Site Address:	16 Langstone High Street, Havant, PO9 1RY		
Proposal:	Proposed Garden Room extension with roof terrace above (retaining previous proposals as approved).		
Application No:	APP/17/00928	Expiry Date:	18/10/2017
Applicant:	Mr Oliver		
Agent:	M Farrer	Case Officer:	Daphney Haywood
	MF Designs Ltd		
Ward:	St Faiths

HPS Recommendation: **GRANT PERMISSION**

Proposed South (Street Elevation)

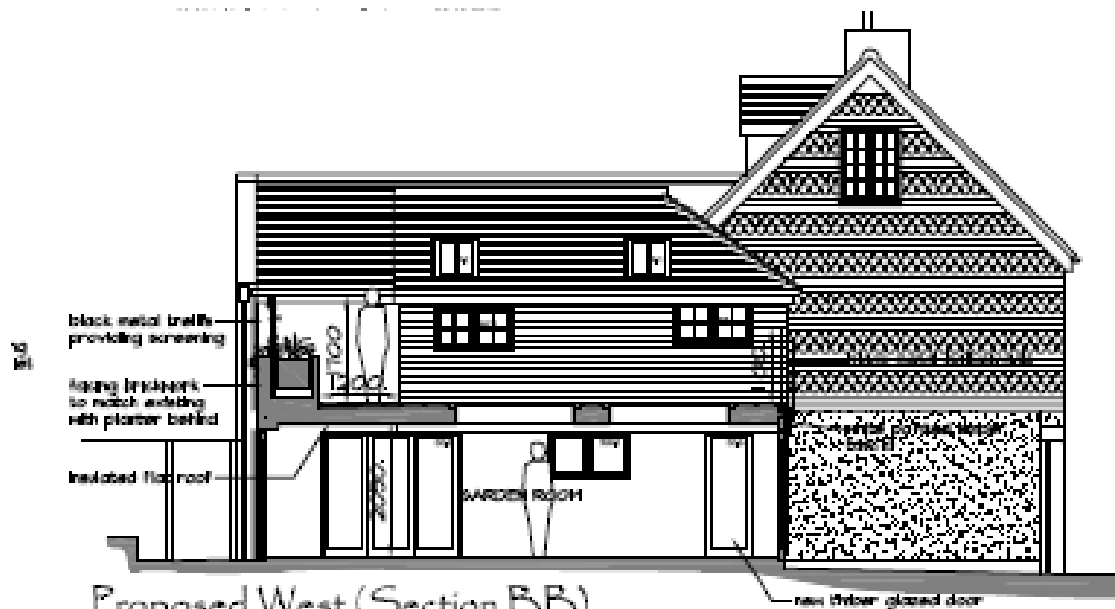
The manner in which the building is viewed means that it is mainly the upper floor that is seen. On reflection I feel the glass balustrade needs amending. Looking at the drawn up plans it does jar with the existing character of the property and the surrounding area. I would therefore recommend the scheme is amended to either remove the balustrading altogether or a more suitable material is used like traditional black iron railings.

This relates to the size of the bathroom window opening at first floor, facing the street. This opening is much larger than other window openings facing the street. Being as it is to serve a bathroom and that the existing house projecting forward of that window would limit views of the harbour, the Conservancy still questions why the opening needs to be that big and being a bathroom why it needs to function as a Juliet balcony?

This window is not annotated as being frosted and whilst the applicant may have no qualms 'appearing' before the unsuspecting public walking in the High Street or along the foreshore, modesty and societal 'laws' of propriety would suggest a planning condition to at least require obscure and fixed glazing to that window, ought to at least be considered by the council!

Notwithstanding similar having been approved under APP/15/00853 and that the Conservancy's objection was misunderstood in the Officer report at that time, a smaller window, central to the width of the wall it sits in would seem more appropriate, perhaps centred on the ridge of the roof over it.

Officer comment: *The balustrading has been amended to black iron railings.*
